# **Design Change/Right-of-Way Re-evaluation**

**SR 570B (CENTRAL POLK PARKWAY)  
FROM SR 570 (POLK PARKWAY) TO SR 35 (US 17) (POLK)**

**FINANCIAL PROJECT ID NO. 440897-2-52-01  
POLK COUNTY, FLORIDA**

**October 2020**

Figure 1: Project Location Map

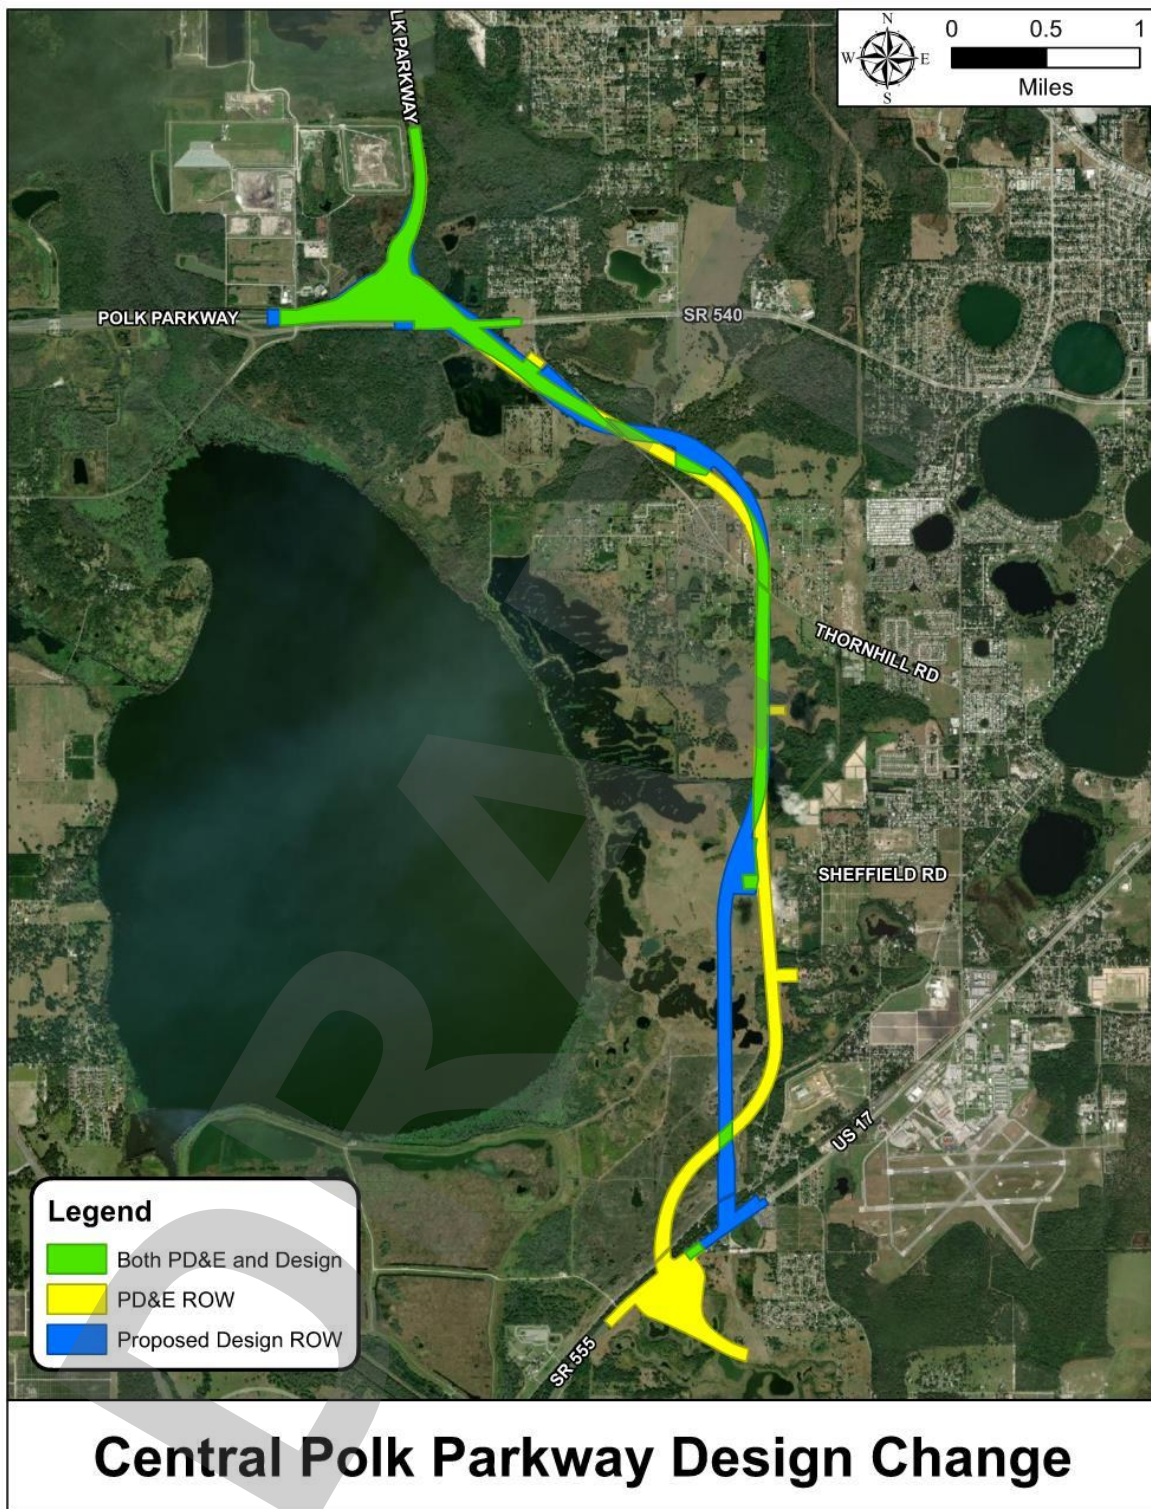
Design alignment changes are shown in the Figure 1.

The proposed CPP mainline alignment was modified along the horizontal curve near the Thornhill Estates development. The revised horizontal curve proposes a higher degree of curvature to avoid two parcel impacts and one structure impact near Country Walk Lane that were impacted by the approved 2011 SEIR alignment. The revised geometry also provides improved sight distance should median barrier be required through the curve.

The preferred alignment from the 2011 SEIR study closely followed but is not parallel to the adjacent existing TECO easement. As a result, the preferred alignment impacted the TECO easement and other existing utilities. The CPP mainline alignment was revised to parallel the existing easement. This resulted in eliminating utility impacts to a Gulfstream Natural Gas, TECO Transmission, and Polk County's sanitary and reclaimed water mains. The revised alignment in this area also eliminates right-of-way impacts to the Polk County Traffic Engineer Operations Complex and bald eagle nests.

**Figure 2: Typical Section**

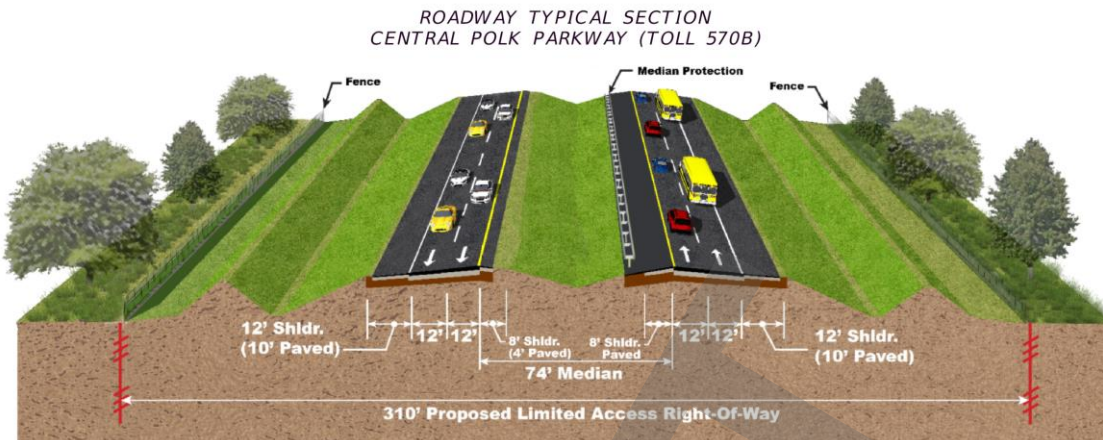
The 2011 SEIR alignment consisted of a six-lane divided limited access roadway with 12-foot travel lanes and 12-foot inside and outside shoulders (10-feet paved) separated by a 40-foot median which could accommodate future widening to the inside.

Since the 2011 study, additional traffic analysis was performed. The Project Traffic Analysis Report (March 2020) projected a 2045 design year traffic volume that could be accommodated by a four-lane facility. As a result, the proposed typical section was modified to provide a four-lane divided limited access roadway with two 12-foot travel lanes in each direction separated by a 74-foot median. The expanded median width provides the required sight distance and accommodates a future six-lane typical section with widening to the inside to address future traffic demand. The inside shoulder width was reduced to eight-feet (four-feet paved), consistent with FDOT Design Manual (FDM) criteria for a four-lane facility.

*Attachment 1: Design Project Location Map*

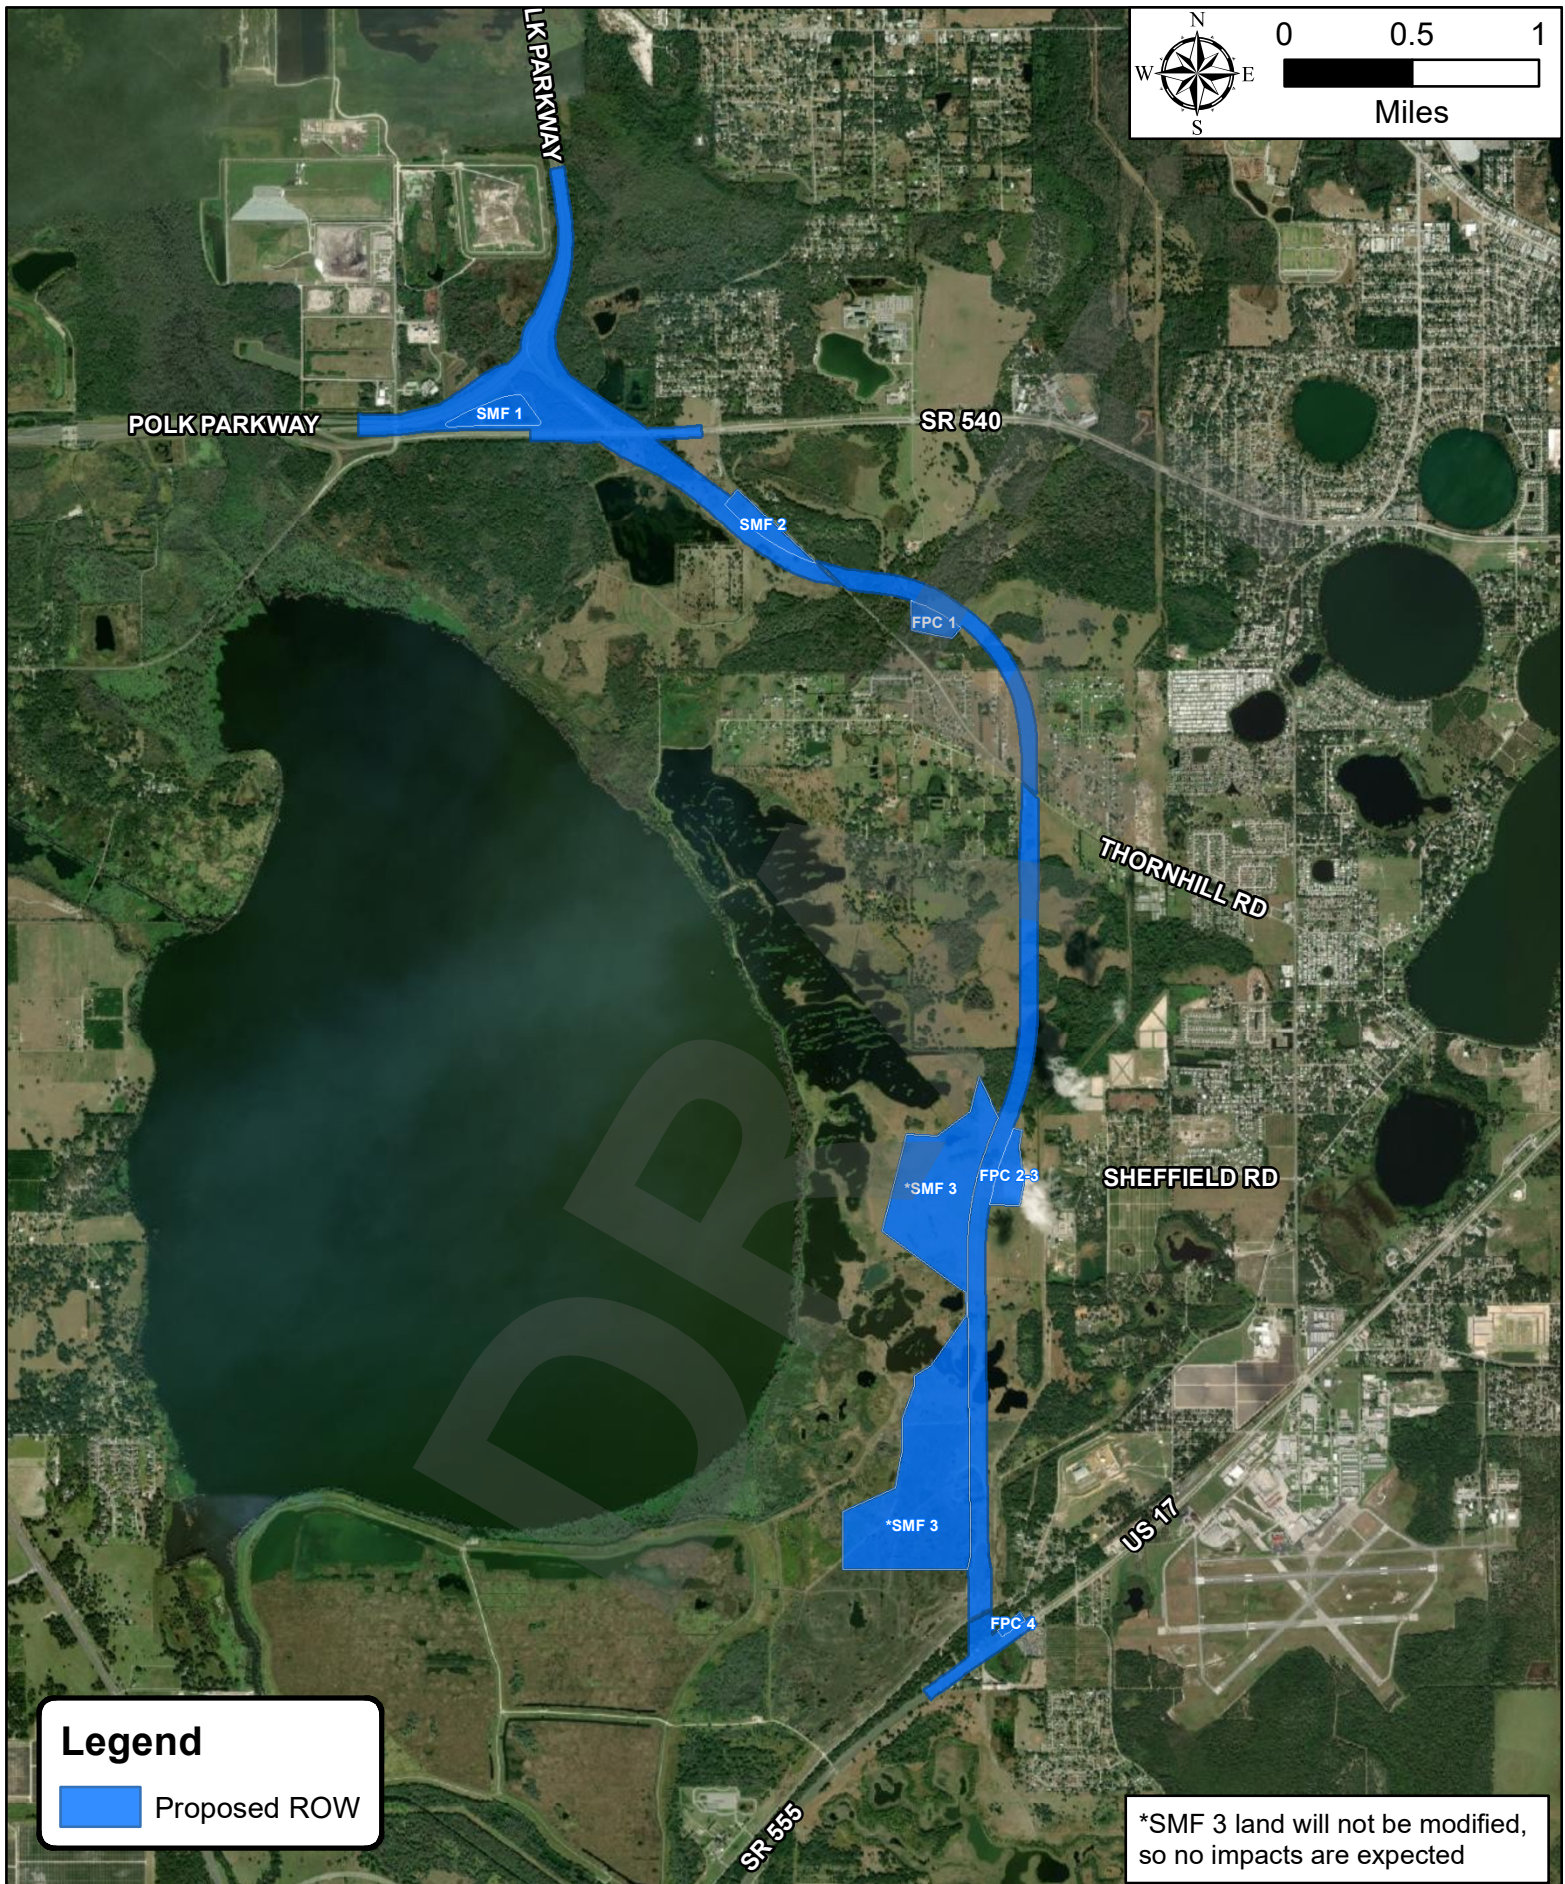
The 2011 SEIR did not assess stormwater management. Stormwater management facilities (SMF) and floodplain compensation sites (FPC) have been evaluated and added to the design (Attachment 1). Stormwater management consists of three SMFs and three FPCs, listed in the table below (Table 1).
